U.S. NUCLEAR REGULATORY COMMISSION
REGION I

Report Nos. 50-277/88-08
50-278/88-08

Facility Name: Peach Bottom Atomic Power Station, Units 2 and 3

Inspection Summary: Inspection on March 14-18, 1988 (Report Nos. 50-277/88-08 and 50-278/88-08)

FIGURE 1 SHOWS N1 (OUTLET) + N2 (INLET) RECIRCULATION NOZZLES WITH NEW SAFE ENDS

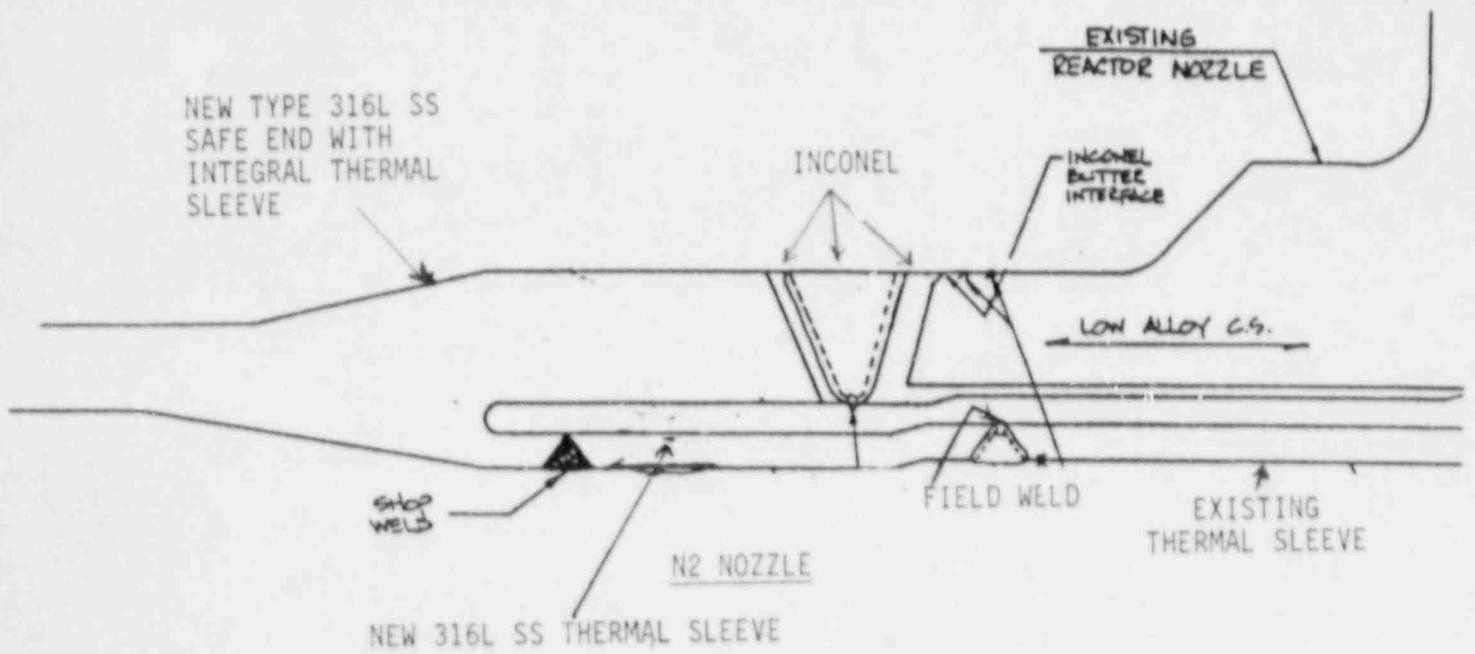
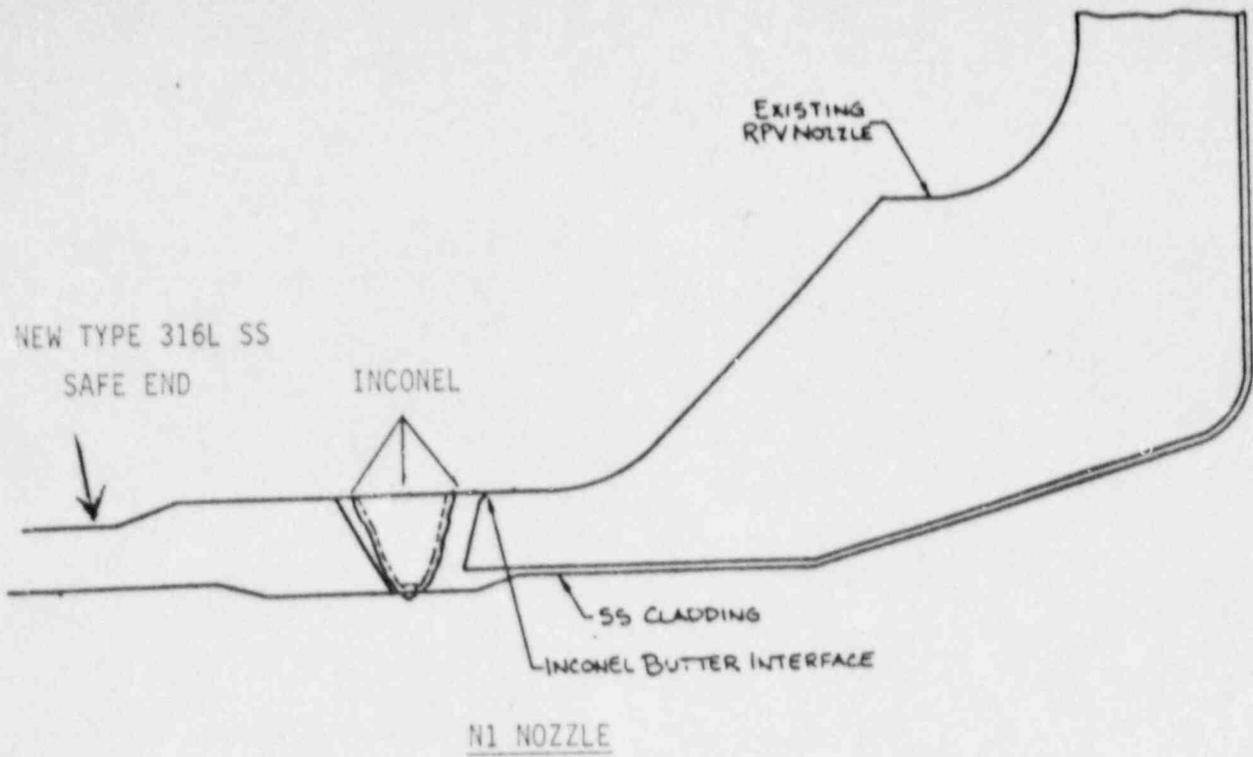
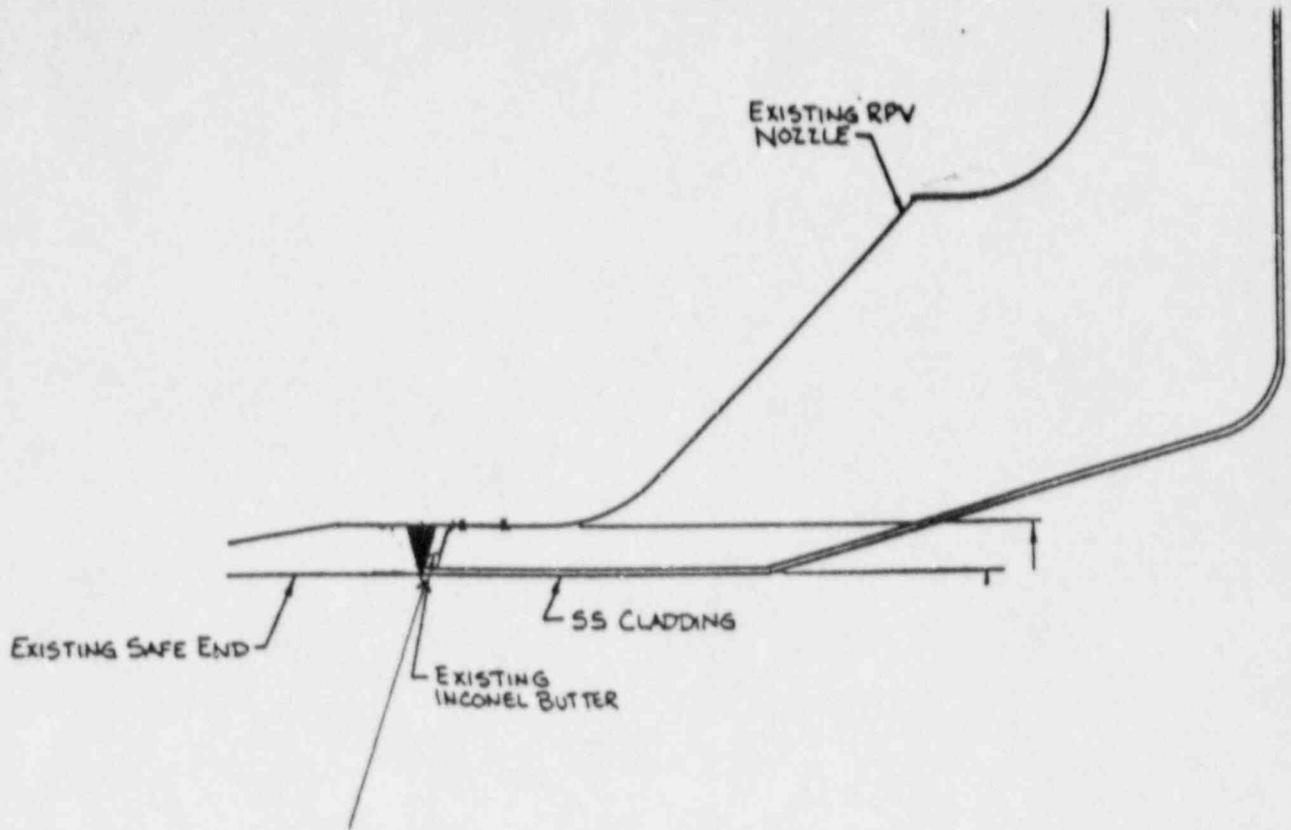
welds in areas where the radiation dose rates are high to minimize personnel exposure. It is noted that the thermal sleeve extension was fabricated in the shop (Ametek) by welding it to an integral projection of the safe end (see "Shop Weld" in Figure 1). The integral thermal sleeve is a new design that avoids welding directly to the safe end and eliminates a crevice condition that has been found to be a site for IGSCC.

The licensee reported that prior to preparing for the installation of the new GE supplied N2 safe ends, a review of radiographs by the PECO Level 2 radiographer revealed unacceptable root conditions (lack of penetration and/or lack of fusion) in five of twelve thermal sleeve extension butt welds (figure #1). As noted previously, the safe ends were manufactured by Ametek, Straza Division, in 1985 under GE P.O. No. 205-854-142. The inspector reviewed the rejectable radiographs and confirmed the root indications, although in some cases the condition could be considered marginal and possibly related to root concavity. A review of the Ametek packages indicated that the radiographs had been reviewed by both GE and the Authorized Inspector. Even though the thermal sleeve welds are not pressure boundary welds, GE had imposed ASME III NB requirements. The rejected safe ends, identified as SN's 1414, 1415, 1417, 1418 and 1424, were returned to GE in Philadelphia for repair and reradiography along with safe ends 1411 and 1413 for which the Ametek radiographs were not located.

FIGURE 2 SHOWS DEFECT IN NOZZLE N1B

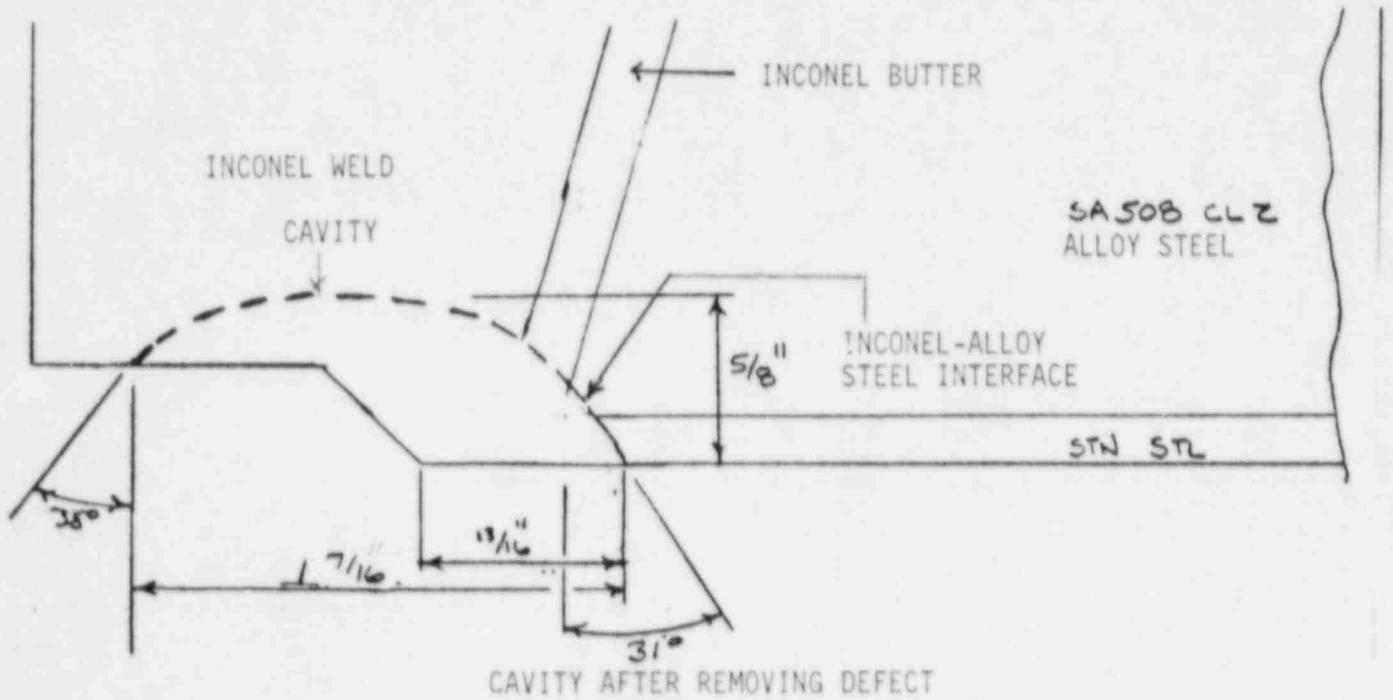
The inspector reviewed the proposed disposition of an axially oriented crack-like indication found in the existing N1B nozzle joint during the replacement of the safe end (see Figure 2). The defect which was revealed by visual, radiographic and liquid penetrant inspection was located on the I.D. surface at the 4 o'clock position. The defect traversed both the RV nozzle to safe end weld and the adjoining nozzle butter. Both the nozzle weld and butter were made of Inconel (alloy 182) weld deposited metal. The defect which was determined to be .287" long was completely removed after grinding to a depth of 5/8". The inspector confirmed the location and physical dimensions of the cavity by visual examination. The cavity was subsequently enlarged to provide 31° and 38° bevels for welding accessibility. The cavity as prepared for weld repair extended into the 308 stainless nozzle cladding and terminated at the interface of the adjoining SA 508 Class 2 alloy steel (Ni-Mn-Mo) nozzle as shown by etching.

The inspector reviewed the proposed Weld Repair Procedure E182 HBR and found it to agree with the temper bead repair technique provided by ASME XI - Article IEB 4000. The procedure employs the manual metal arc process with the half bead technique (removal of 1/2 of the first deposited layer prior to depositing the second layer), a 300°F preheat, and a low temperature (500°F) stress relief after welding. The electrode used for the repair in this instance is Inconel 182 which is compatible with the existing materials, i.e., Inconel weld and butter, type 308 cladding and (Ni-Mn-Mo) alloy steel. The preheat and stress relief are intended to protect the alloy steel nozzle. The preheat removes hydrogen and retards the formation of brittle martensite. The stress relief provides a tempering (softening) effect if martensite were to form.

The inspector verified that the proposed weld repair procedure and the associated Work Package conformed to the procedural and qualification requirements of ASME XI, Article IEB 4000. The latter included both bend and impact testing and special welder training. The weld repair was initiated on March 16, 1987 and completed on March 17, 1987. The traveler indicated that the repaired area will be subject to liquid penetrant, radiographic and ultrasonic inspection 48 hours after the repair is completed. It should be noted that the repair procedure qualification test assembly is far more conservative than the actual repair. The former consisted of a 1" deep cavity in a 6" thick alloy steel test assembly compared to the condition in the nozzle in which the cavity just barely penetrated the base metal at the nozzle/cladding interface. It should
